## PRODUCT / PROCESS CHANGE NOTIFICATION

| 1.2 PCN No.          |   | APG/14/9004   |
| 1.3 Title of PCN     |   | VIPower housed in PowerSO-30: Wire Sagging Improvement        |

### **Package MultiPowerSO30 New frame for sagging wire improvement**

# VIPower housed in PowerSO-30: Wire Sagging Improvement

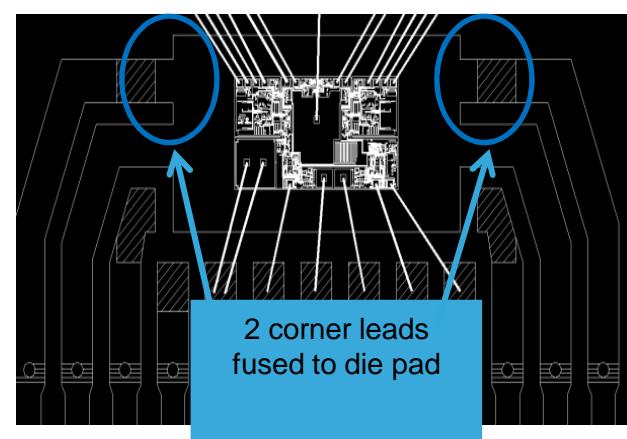
Current

No corner leads are fused together in

New

Corner leads are fused together in order to improve wire sagging and to avoid pad tilt/movement during handling

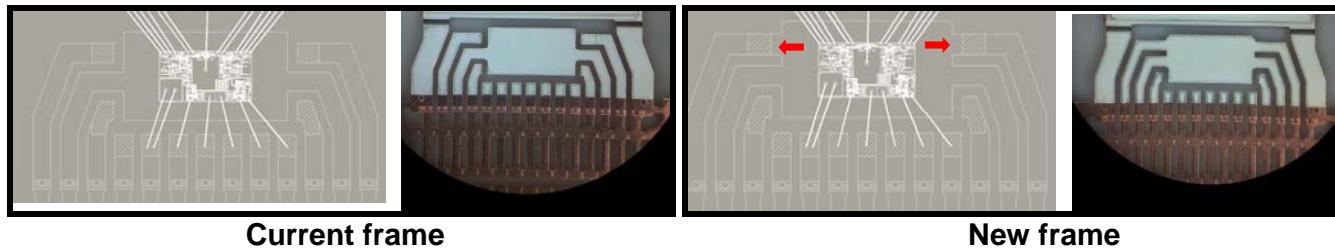
The new frame is introduced for sagging wire improvement and was designed to make the floating paddle more rigid reducing the vertical vibration during handling.

Change between the current and the new frames occurs only in a geometry dimension (see red arrows for details) but not in the material or in the assembly configuration.
